I. TECHNICAL SPECIFICATION CHANGE REQUEST (TSCR) No. 159

II. REASON FOR CHANGE

Figure 2.1-2

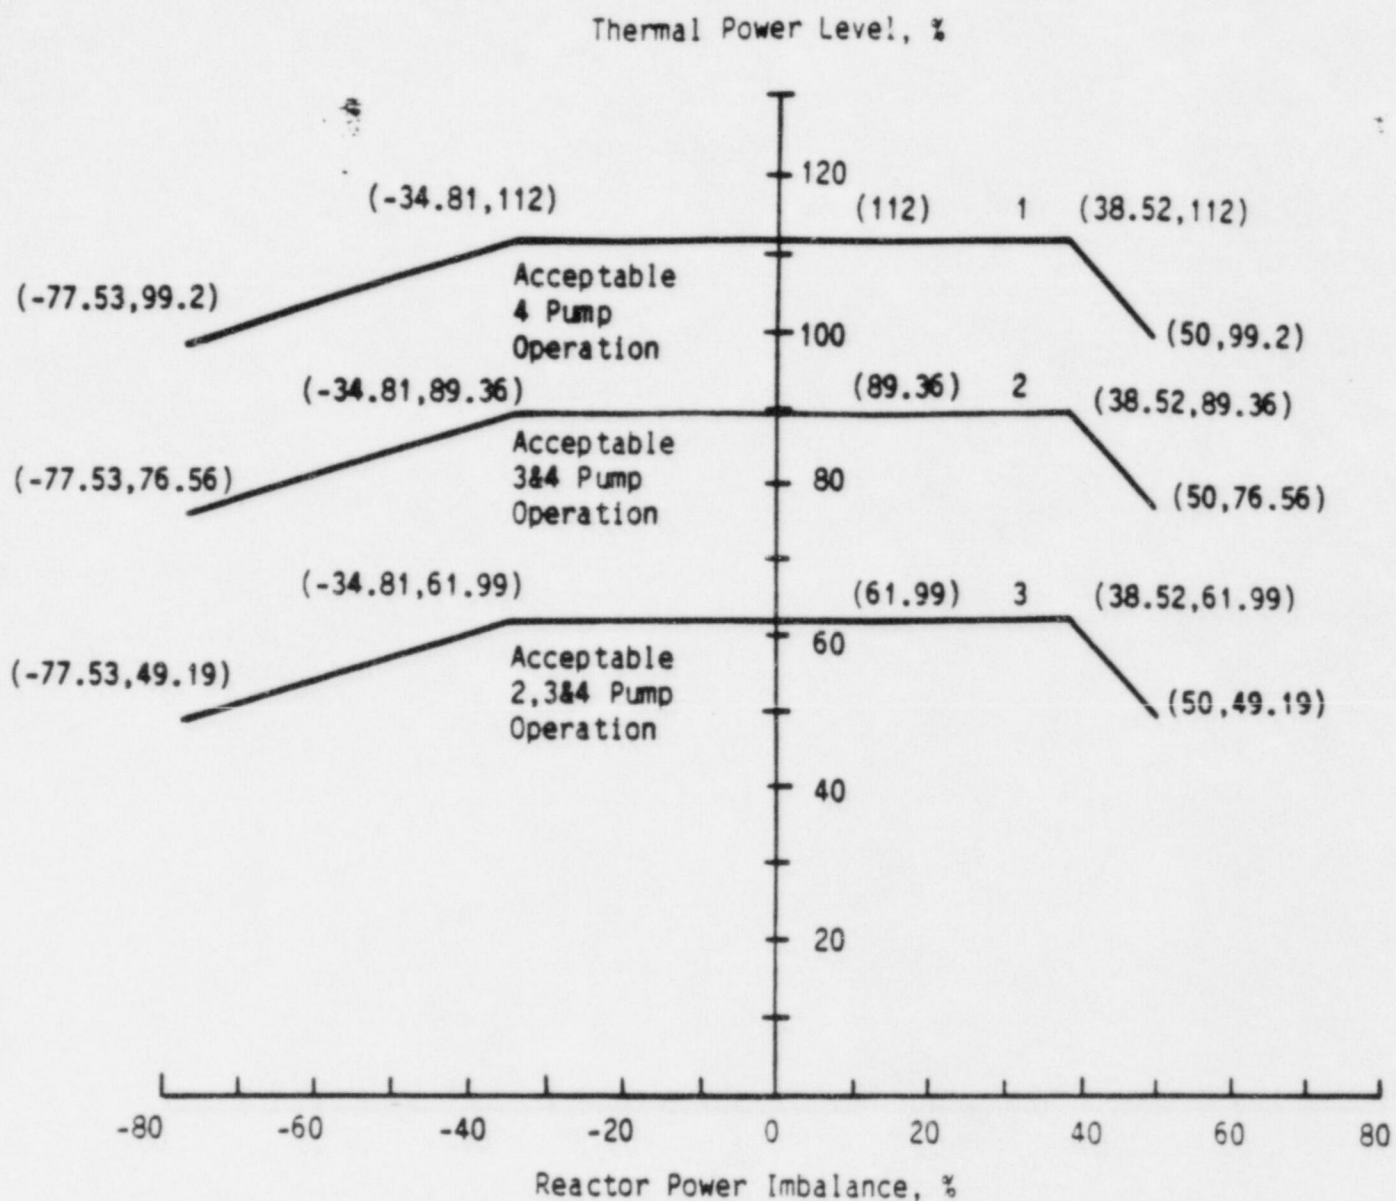
Core Protection Safety Limits

The TMI-1 Cycle 5 RPS power/imbalance/flow Technical Specification setpoints and safety limits were reevaluated for the APSR withdrawal and cycle extension. In doing so, the setpoints and safety limits were expanded to ease operational concerns associated with the APSR withdrawal and cycle extension. The expansion of the envelope is made possible by the existing margin between the power-power imbalance limits actually calculated for Cycle 5 and the original Cycle 5 Technical Specification safety limits which were established very conservatively with the intention of bounding future cycles. The revised Technical Specification setpoints and safety limits preserve the original power-power imbalance limits generated for Cycle 5, while increasing operability by taking advantage of a portion of the available margin.

Figure 2.3-2

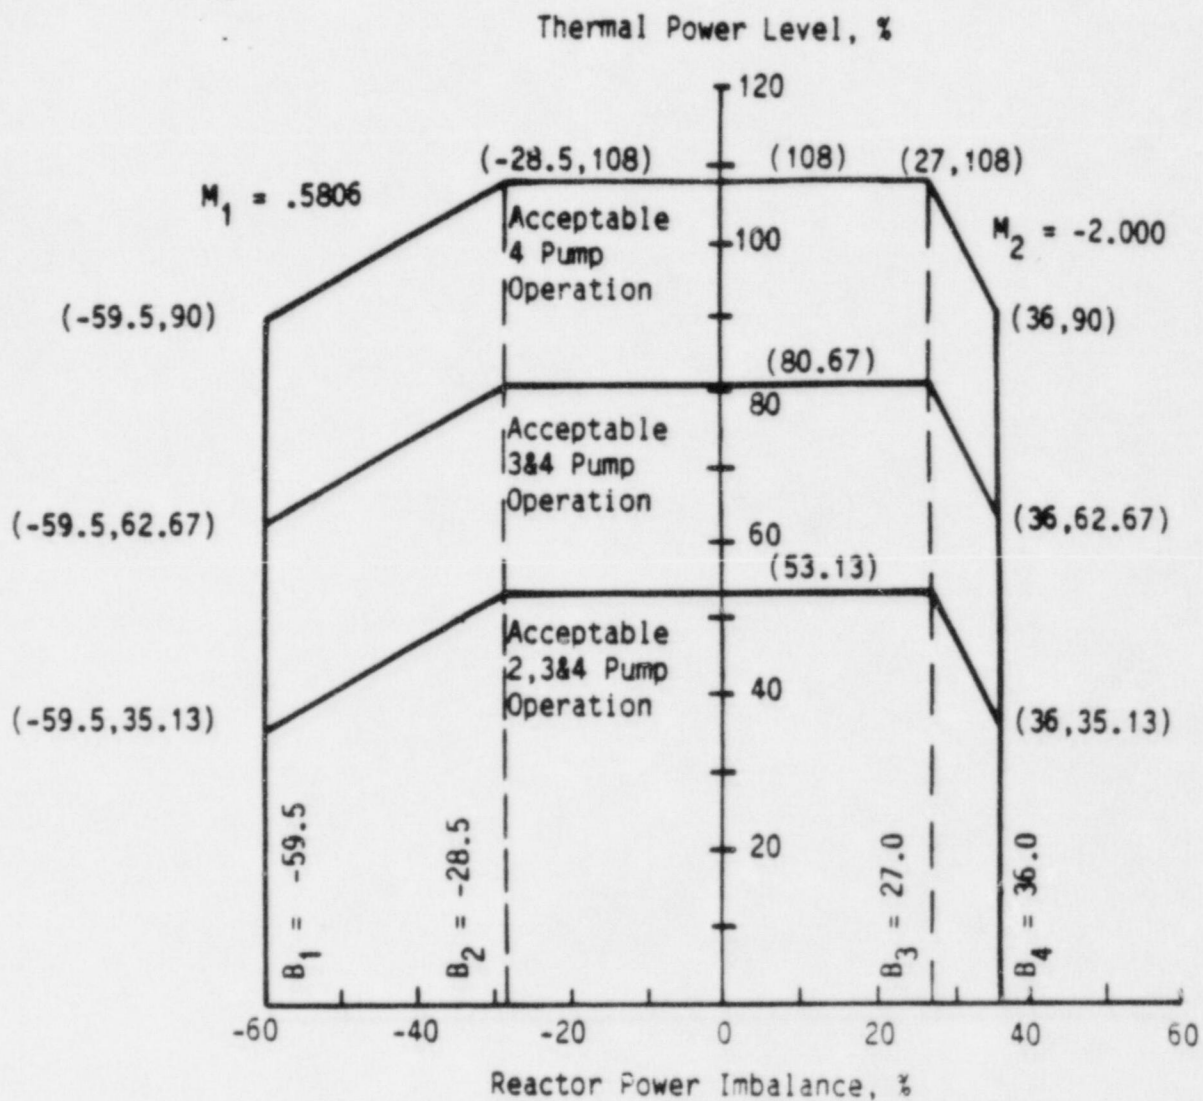
Protection System Maximum Allowable Setpoints for Reactor Power Imbalance

Figure 3.5-2E

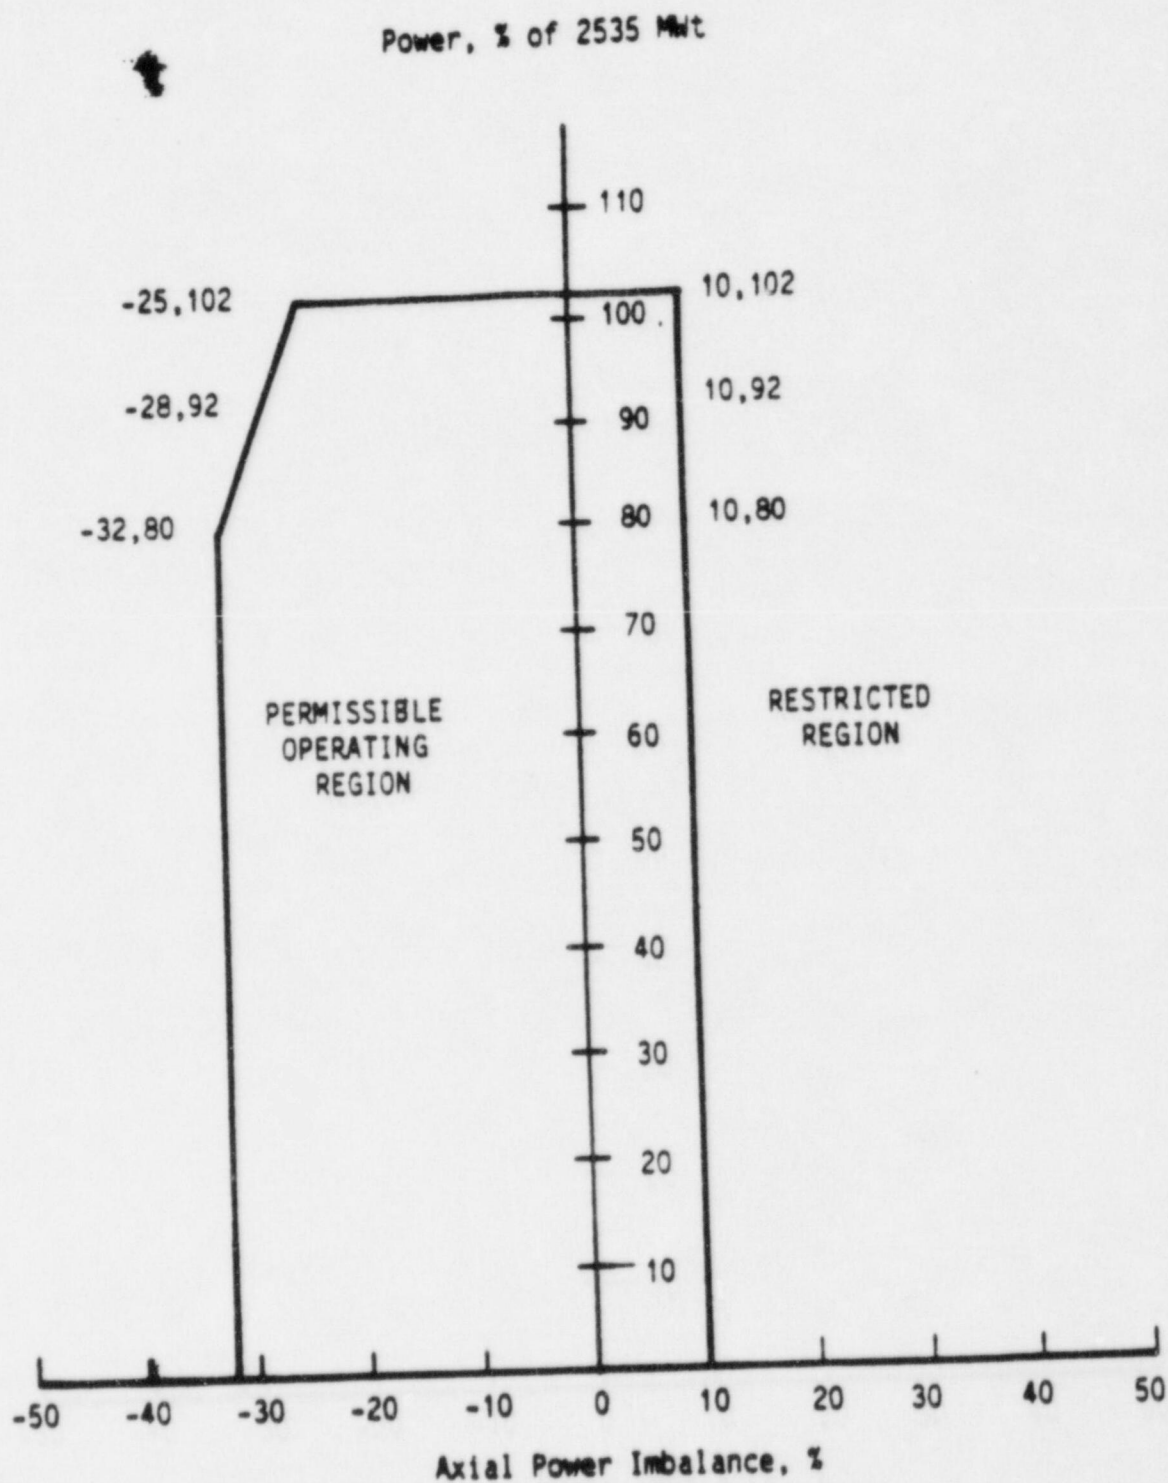
### Power Imbalance Envelope APSR Position Limits

The changes provide wider imbalance windows and prohibit APSR insertion after  $250 \pm 10$  EFPD to EOC. Other Technical Specification limits were evaluated and need no revision. The evaluation also assured that the revised limits are still consistent with the Technical Specification bases.
